Product/Process Change Notice (PCN)

PCN #: PCN_AsSMSI_20180312

WA-SMSI 9774090360R / 9774100360R

WA-SMST 9774090960R / 9774100960R

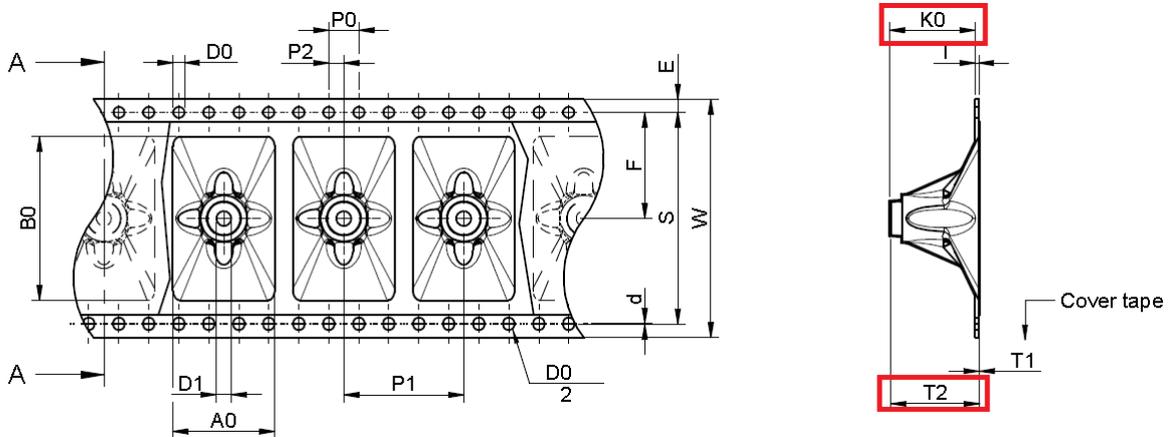
In order to improve the transportation and handling safety, Würth Elektronik will modify the dimensions of the cavity of the carrier tape. This will lead to a change of the packaging unit.

Due to reducing the height of the cavity, where the parts are located into the carrier tape, the dimension K0 and T2 will be changed.

| 9774090x60 | Dimension | Before Change | After Change |
| | K0 | 14,20 | 10,70 |
| | T2 | 14,50 | 11,00 |

| 9774100x60 | Dimension | Before Change | After Change |
| | K0 | 14,20 | 11,70 |
| | T2 | 14,50 | 12,00 |
